SITE MONITORING REPORT

To	David Parsons (Ridge), Mark McClean, Carl Turner (Knowles)
Mode of Transmission	via email as pdf file
Date	06.07.17
Date of site visits	05.07.17
Instruction	Upper Redlands Road
FLAC Instruction ref	CC31-1036
Client	Reading University

Marked-up TPP to show alignment of enhanced tree protection fencing for works associated with either retaining wall or batter construction

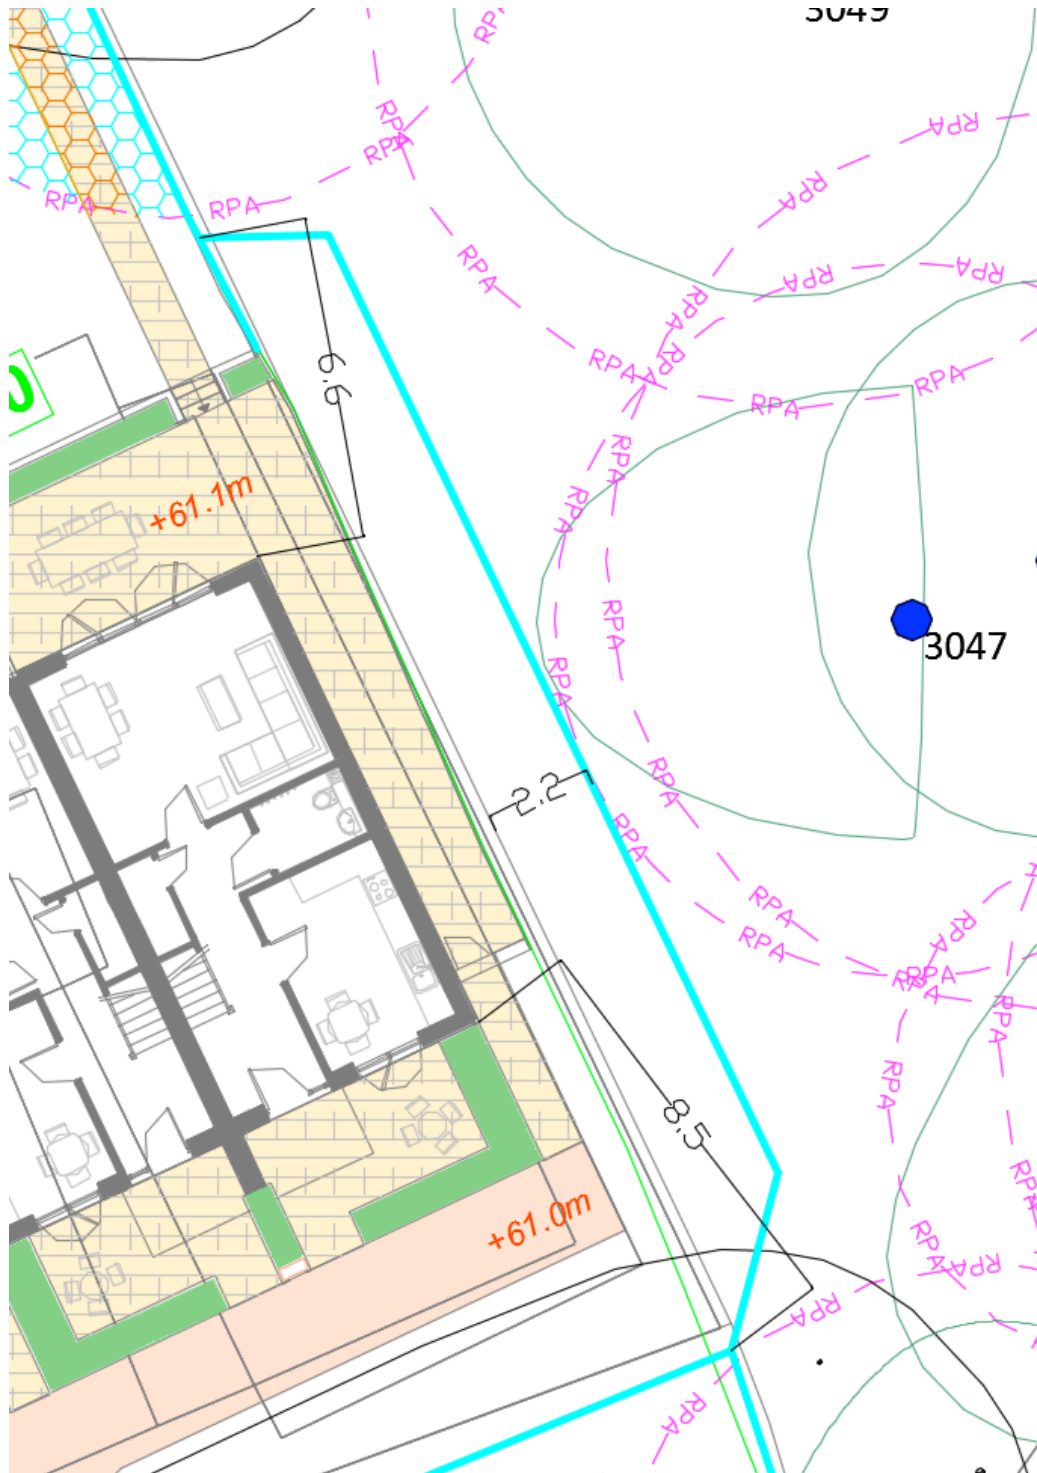
2. The main focus of my advice relates to the construction of a retaining wall parallel to the east flank of the east unit (number 10). The section to receive this retaining wall runs from virtually level with the south-east corner of the unit and extends to approximately 3 metres beyond the north-east corner. The wall is located outside the root protection areas (RPAs) of retained trees beyond the east site boundary

3. I understand that engineers have recommended a substantial concrete footing and that Knowles are exploring the options to reduce the extent of engineering, possibly to a batter back down to the existing levels. The wall at its highest point is +600mm, a corresponding batter with 1:3 fall would have a horizontal land take of 1800mm. All things being equal this would terminate 400mm short of the first RPA, being 2200mm from the retaining wall, at horse chestnut 3047, existing level differences may vary the actual dimensions

4. In any event the protection of trees to the east will require a more substantial barrier to be installed prior to work for either a wall or batter commencing. The current situation is that with the scaffolding in place access down the east flank is greatly restricted so orange mesh on lamp irons has provided a visual demarcation of the limits to access since the old chain link fence was removed

5. The current alignment of the mesh is likely to be satisfactory in terms of access facilitation for the wall/batter if extended to the north but proximal activities will require a suitably robust barrier replacement, to that end I recommend: herras panels on boots, pinned into the ground; panels clipped together and braced horizontally; supported by individual back braces, also pinned into the ground
6. This is not the typical fully driven scaffold framework but I consider it to be suitably robust with consideration of the location, close scrub vegetation and the level of construction activity. NB please would Knowles contact FLAC a week before the new fencing so that we may record the replacement tree protection fencing once installed

7. The area site-side of the tree protection fencing on the mark-up is free of RPA constraints, assuming no incursion beyond the fencing alignment mechanical excavations may take place, concrete may be used and any roots encountered may be severed. NB trench for wall footings will be in the region of 2 metres beyond the extremity of the closest RPA

8. I would advise that the new fence alignment is pegged out, noting the maximum offset as shown on the mark-up above, to determine if any access facilitation pruning is required. If pruning of the scrub is necessary I advise that an arboricultural contractor is instructed to undertake this, per the arboricultural method statement. They could also undertake the removal of the sycamore (see item 10 below) and the outstanding pruning works per the specification provided on the tree protection plan 31-1036.06-C dated 26.01.17

9. The new tree protection fencing must remain in situ until the boundary fence is installed because without the scaffolding, access along the flank of the unit is feasible consequently access beyond the site must be prevented
